Washington Public Power Supply System
A JOINT OPERATING AGENCY

Subject: PROPOSED STANDARD REVIEW PLAN (PSRP) 3.9.6, REV. 2

COMMENTS ON SRP 3.9.6

The configuration for BWR ECCS systems is shown below:

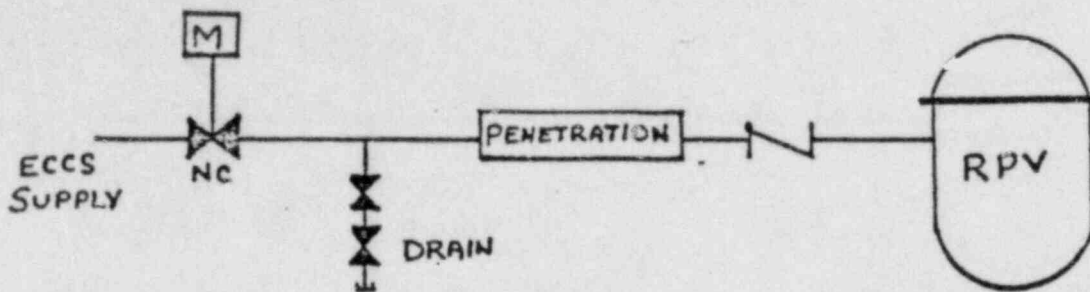
The SAI report (EPRI NP-262) states that for the case of the two check valves in series with a MOV that "the interfacing-system LOCA seemingly must occur through two check valves and a motor-operated valve. With the system designed in this manner, however, failure of the two check valves is negated only until monthly opening (Section XI only requires valve exercise tests once every three months) of the MOV". SAI further states that only a complex procedure, such as leak testing could indicate the failures of the check valves prior to the opening of the MOV. The case is similar to that of the BWR except in the BWR there is only one check valve inside of the containment and the MOV is outside of the containment.

An alternate test method which would achieve the NRC's goal of decreasing the probability of intersystem LOCA would be to vent the pressure between the check valve and MOV prior to exercising the MOV. This could be accomplished by opening the drain valve. This would ensure that the check valve was functioning properly. Then the MOV could be safely exercised. It is important to realize that the analysis presented by SAI in EPRI NP-262 and the NRC in NUREG 0677 assumes either the check valve(s) rupture or fail by gross leakage. Leak testing per se does not decrease the
